***Cycling Infrastructure Audit***

***Westport Smarter Travel – Cycling Audit Report***

**November 2013**

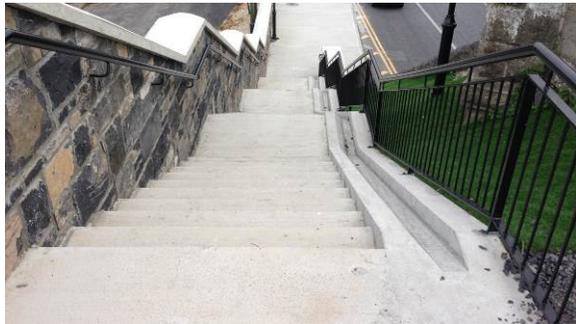
2.	The 'Granary' residential vehicle crossing.	<p>There is no warning signage provided either on the greenway, or on the residential access road crossing the greenway, warning cyclists and motorists about the risk of encountering cyclists and vehicles at the crossing.</p>	 <p>Granary house crossing – no warning signage.</p>	<p>Warning signage should be erected on the greenway on both approaches to the crossing to warn fast moving cyclists in particular of the potential danger. A warning sign should also be provided on the access road approach in the southern direction.</p>

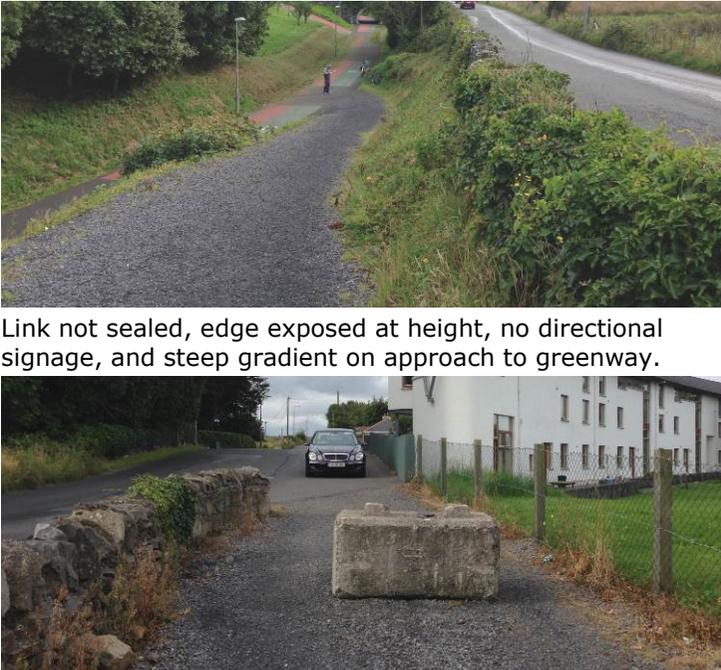
11.	Greenway link to The Elms estate	<p>1. There is no direction or information signage at the junction with the greenway stating that the link is to a residential estate.</p> <p>2. The gradient linking the estate to the greenway is very steep.</p>	 <p>No direction or information signage at link junction. Steep gradient on approach to greenway.</p>	<p>Direction and information signage should be erected at the junction with the estate link displaying the estate name and the direction to the town centre and the Quay as well as distances to each.</p> <p>Guard-railing (at junction) and/or fencing (opposite T-junction) should be provided at the link junction with the greenway to prevent cyclists overshooting on approach and coming into conflict.</p>
